**From:** [Biazar, Shahab](#)  
**To:** "Richard Medina"; [ccealbq@aol.com](mailto:ccealbq@aol.com); [Chen, Tiequan](#)  
**Cc:** [Mercedes Lopez](#); [Steve G. Herrera \(sgherrera@cabq.gov\)](mailto:sgherrera@cabq.gov); [Steve G. Herrera \(sgherrera@cabq.gov\)](mailto:Steve G. Herrera (sgherrera@cabq.gov)); [Renee C. Brissette - City of Albuquerque \(rbrissette@cabq.gov\)](mailto:Renee C. Brissette - City of Albuquerque (rbrissette@cabq.gov))  
**Subject:** RE: 1998 Cherokee NW (F13D034)  
**Date:** Tuesday, June 6, 2023 1:51:00 PM  
**Attachments:** [image001.png](#)

## DRAINAGE AND TRANSPORTATION INFORMATION SHEET

## GRADING & DRAINAGE PLAN

Clark Consulting Engineers			
Edgewood, New Mexico 87015			
Tel: (505) 281-2444		CELL: (505) 264-6042	
DATE	REVISION	LOT 2-A-1, LAND OF BETTY SKOGEN ALBUQUERQUE, BERNALILLO COUNTY, NEW MEXICO	
		1998 CHEROKEE RD, NW	
		<b>GRADING &amp; DRAINAGE PLAN</b>	
DESIGNED BY: PWC	DRAWN BY: CCE	JOB #: 1998 Cherokee	GD-1
CHECKED BY: PWC	DATE: APR. '23	FILE #: G/D

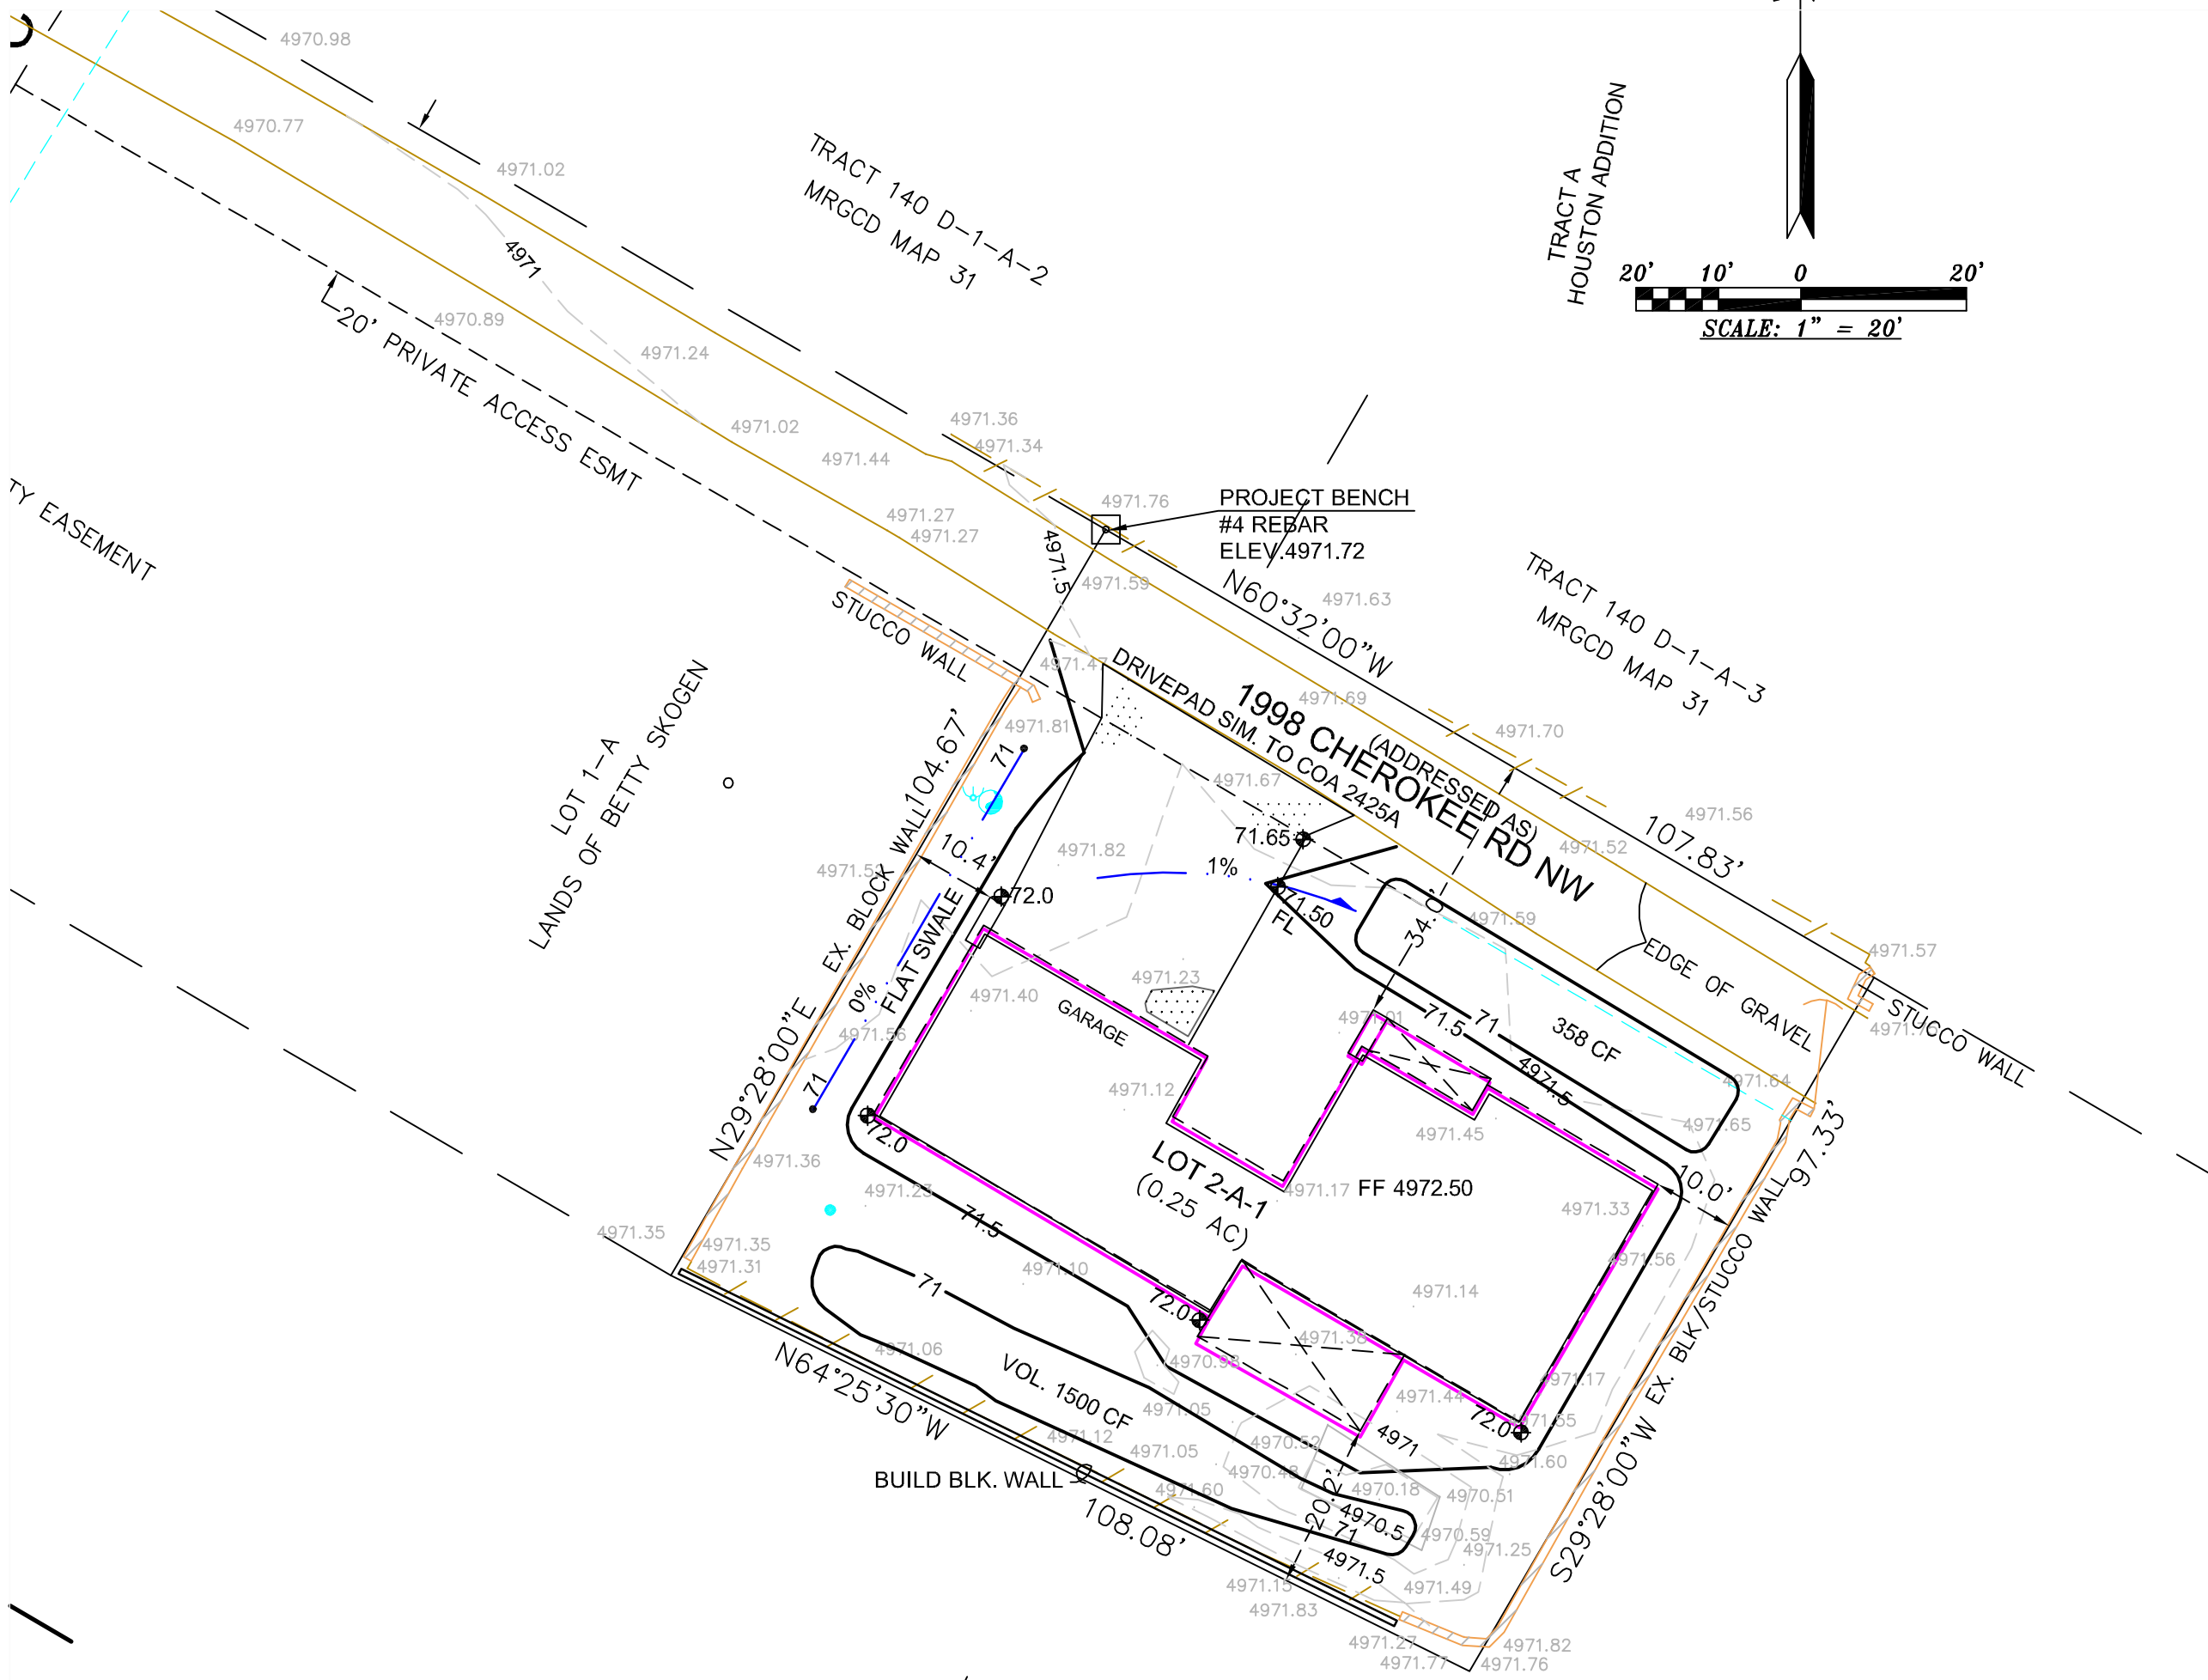
I went back and checked the volume shown on your plan one more time, and it appear that the ponding provided will required +/- 300 cf of additional volume. And the easy fix would be simply to lower the bottom of the pond slightly (0.25') to meet the required volume. Please revise your plan per previous email, and resubmit to [PLNDRS@cabq.gov](mailto:PLNDRS@cabq.gov), and we should be able to approve the plan. The changes should not take more than few minutes.

Please see attached exhibit and calculations. I believe we may need to lower the bottom of the pond in the front and in the back by 0.25' (to 70.75) to provide adequate ponding. Please go ahead and resubmit the plan and update calculations to [PLNDRS@cabq.gov](mailto:PLNDRS@cabq.gov).

There are two ponds with volumes shown one in the back and one in the front. Can you please provide pond volume calculations. What is top/bottom of pond elevations/limits as well as the areas in square foot.

Hi Phil:  
Please address our comments with a response letter and resubmit the plan to  
[PLNDRS@Cabq.gov](mailto:PLNDRS@Cabq.gov). Your plan does not support your calculations. You may include cross-  
sections for your ponds.

I cannot see how elevation 4971.5 is the top of your pond. This new contour does not close with itself to form a top of pond. This site is very tight and I think the house maybe too big for the lot without doing an underground system. I don't agree with your assessment. You can talk to my boss, Tiequan Chen at 505-924-3695 if you think that you can get this volume with your current design.

There is no way that you have this volume.

1. Pad certification will be required prior to building permit approval.
2. Bottom of the ponds must be lowered by 0.25' to 70.75'.
3. Final as-built certification will be required prior to release of Certification of Occupancy.
4. Please attached the grading plan with engineer stamp date 4/26/2023 to the building permit set.

I really do not have the resources at this time to resubmit, therefore, would you please consider to allow lowering the pond (or raising the FF) 2-inches as a condition of the As-Built certification. Based on my calcs and reasonable tolerances (0.1' plus/minus) that would seem practicable to resolve your concern.

It ties into a solid wall. I have presented two options with supporting calcs. The first is calced to the 71.5 contour (top) with FF @ 72.5, OR the second version also sent calculates the rear pond to a top (L-shaped) elev. of 71.8, and raised the FF to 72.8 (1'+ as "recommended" by 6-5(D), not necessarily required). This scenario ties into the existing 71.8 spot elevation.

Renee,  
The front pond is calced correctly Top is 71.5, bottom is 71.0, 890 sf + 500 sf/2 x 0.5'  
= 350 cf  
the rear pond is cacted as follows, and completely walled in:  
Top, 72.0 contour, 2753 SF  
Bott, 71 contour, 621 SF, thus 2753+621/2 x 1 = 1681 CF > 1500 CF called out
